PARTS & SERVICE NEWS

AA02064

SUBJECT: REPLACEMENT MOM (MESSAGE for OPERATOR and MAINTENANCE) DISPLAYS (7818 92 2003) and MOM WIRING REWORK KIT (XK0025). ALSO PMC UPGRADES.

APPLICATION: Komatsu Dump Trucks:
530M: A30001 through A30038
HD1500: A30045 & A30046

FIGURE 1. CAB REWORK

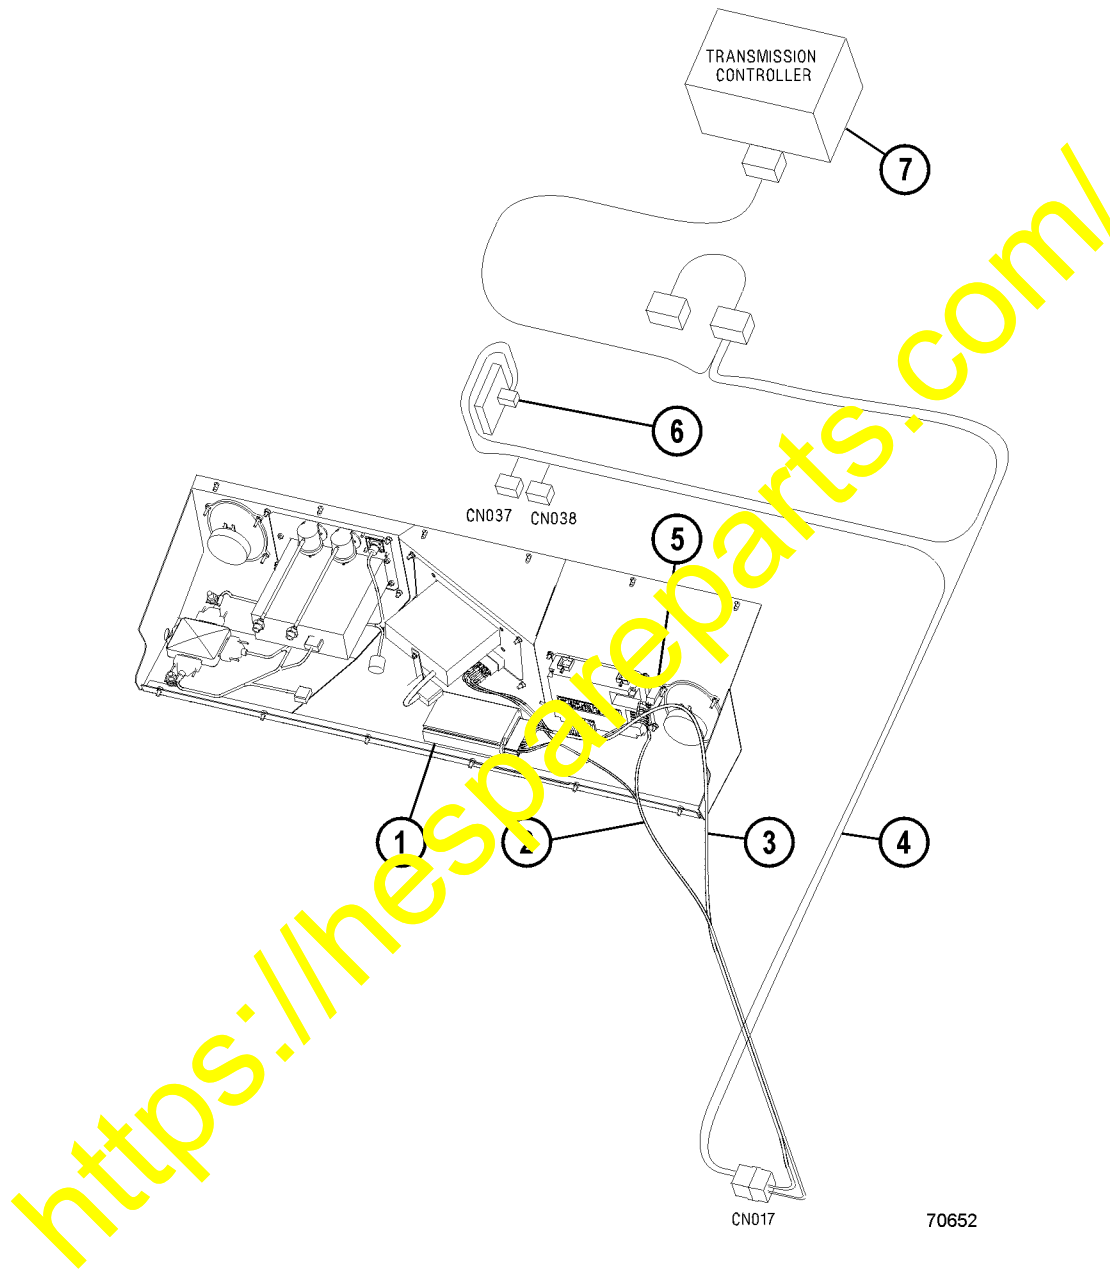
Kit (XK0025) includes a DC-DC Converter (1, Figure 1) to be mounted in the overhead panel behind the MOM Display unit. The converter filters transient voltage spikes and maintains 24 Volts supply power to the MOM display unit.

A 0.5 ampere circuit breaker (5, Figure 1) is also added to the truck to protect the wiring in the unlikely event that an internal failure in the MOM display unit would occur. The circuit breaker is installed in the overhead panel next to the MOM display and the button protrudes through the panel. If the circuit breaker is ever tripped, it will generate the fault of "Inclination Angle High". This fault is normally only triggered when the body is raised during dumping and the side-to-side truck angle is excessive. If this fault is logged in the event recorder, but the body was down at the time, it is likely that this circuit breaker was tripped. When this fault is triggered (regardless of the reason), the respective light in the Left Hand Pod of the main instrument panel will illuminate, the "Caution light" will blink and the alarm will sound.

FIGURE 2. MOM WIRING SCHEMATIC AFTER REWORK

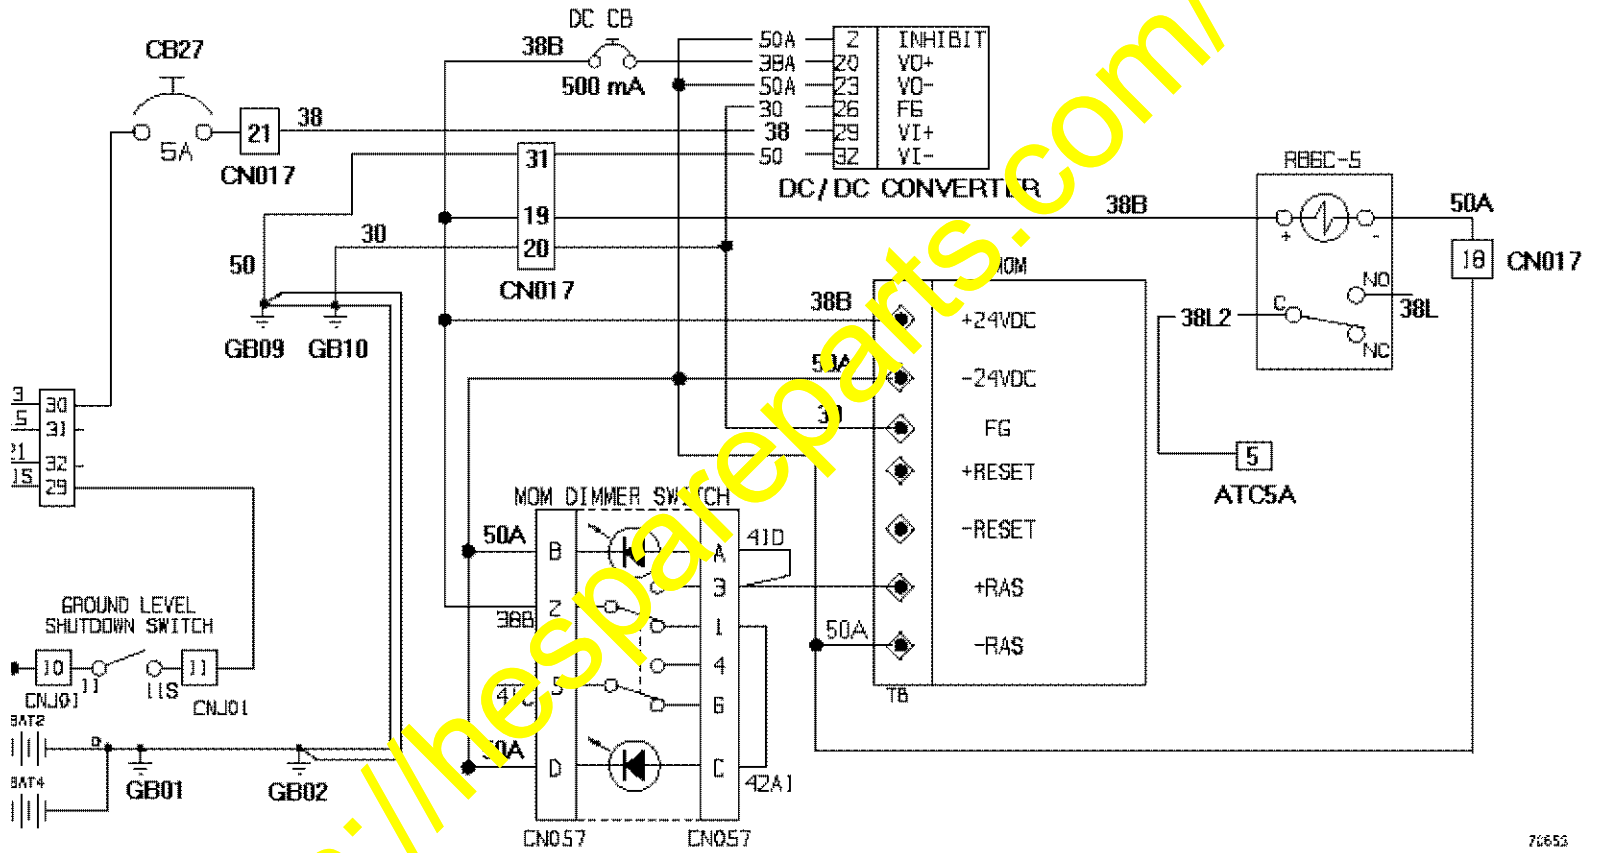
The MOM Wiring Rework Kit part number (XK0025) makes several improvements to the 24 Volt electrical system on the truck. These improvements also increase the performance and reliability of the MOM Display unit.

The kit also adds several chassis grounding cables which are intended to prevent potential electrical buildups within the chassis and deck structures.

An electrical noise/surge suppressor is also added to the truck on the circuit that supplies current to the air conditioning compressor clutch. This reduces electrical impulse noise which occurs every time the coil in the clutch is de-energized.
